Re: ACTION RE: PETITION FROM SURGERY CENTER OF GREEN BAY – SITE PLAN AND DESIGN REVIEW ON PARCEL AL-2127, LOCATED AT 2825 S WEBSTER AVENUE

Date: 03 March 2017

Site Plan & Design Review – Staff Comments

LANDSCAPE
PLAN

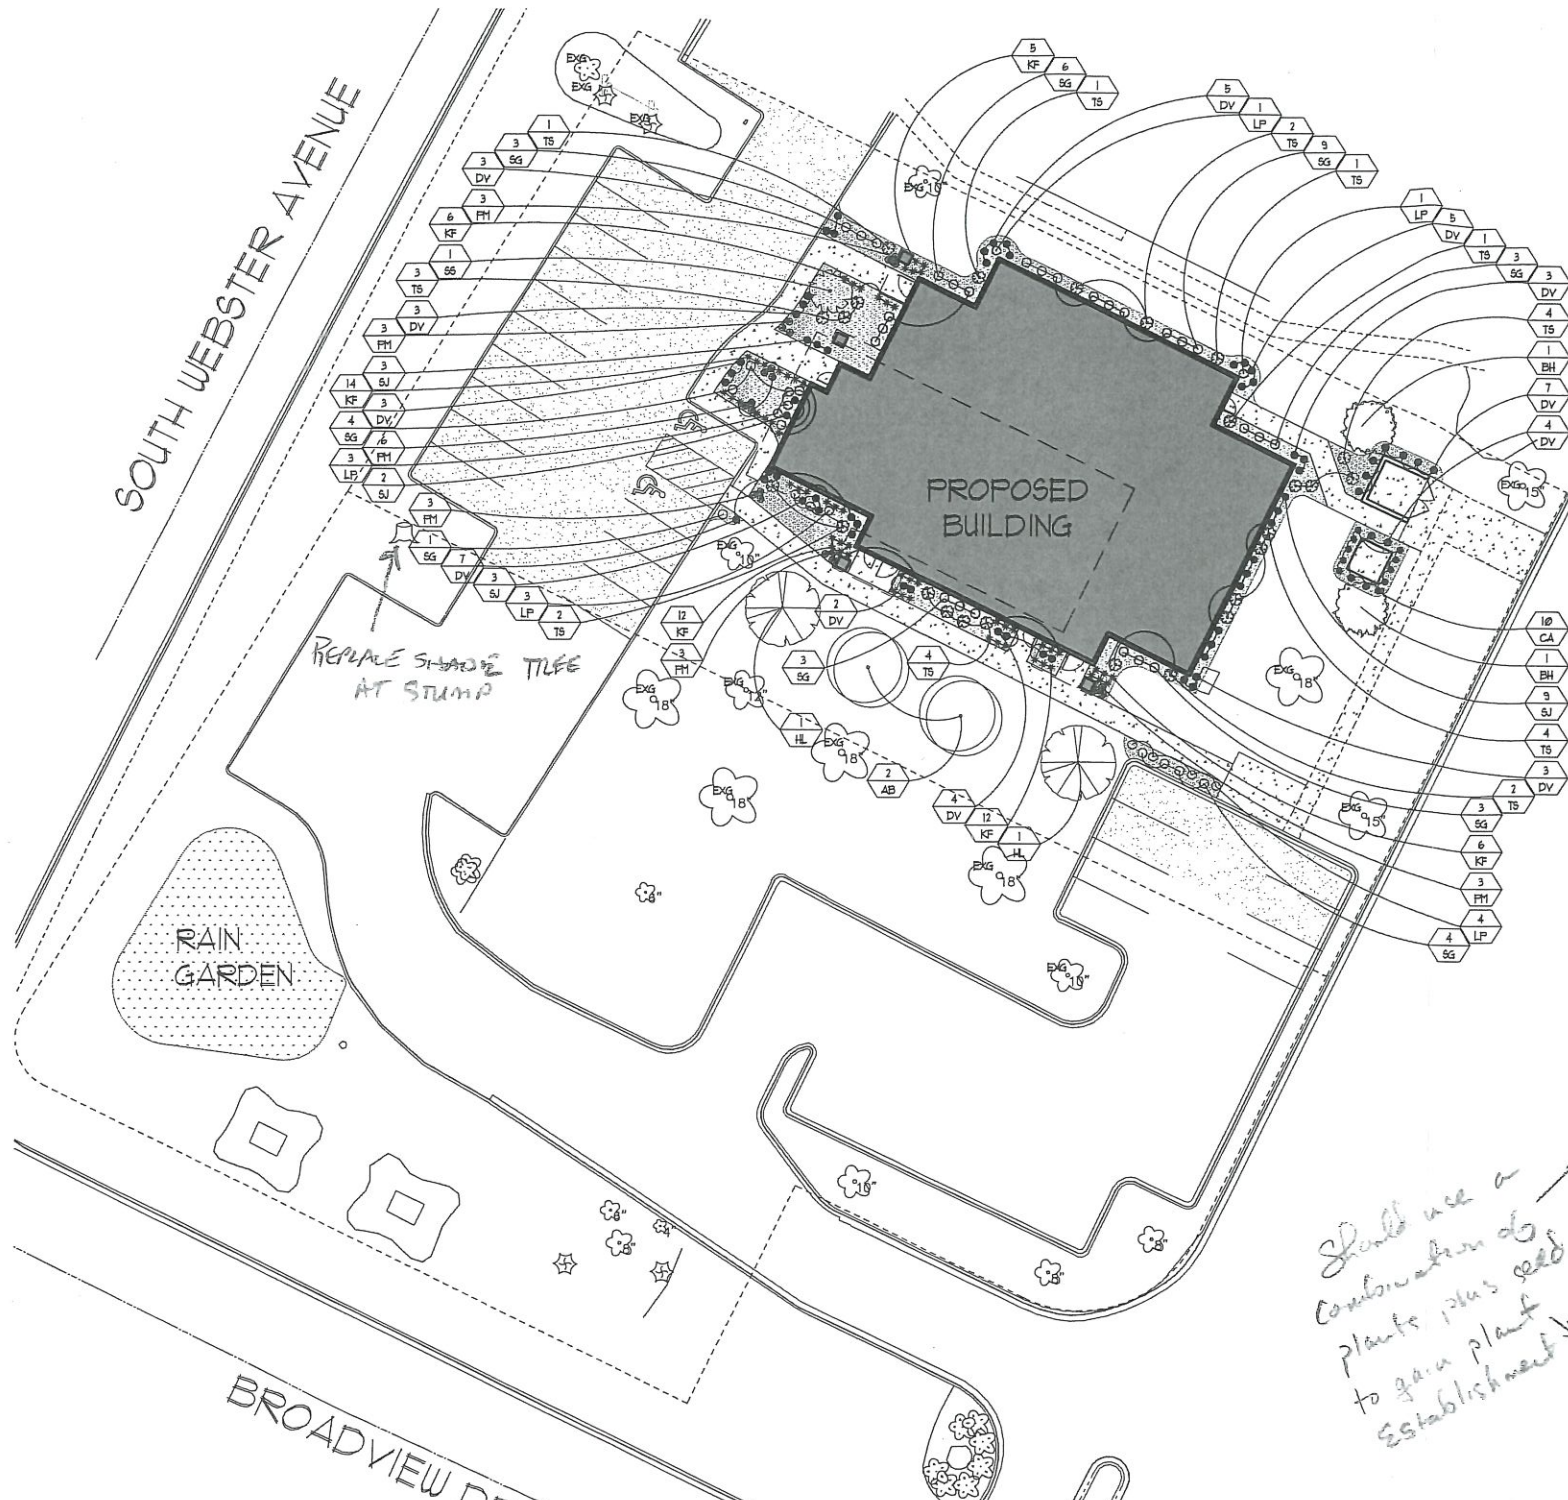
Should use a combination of plants plus seed to gain plant establishment
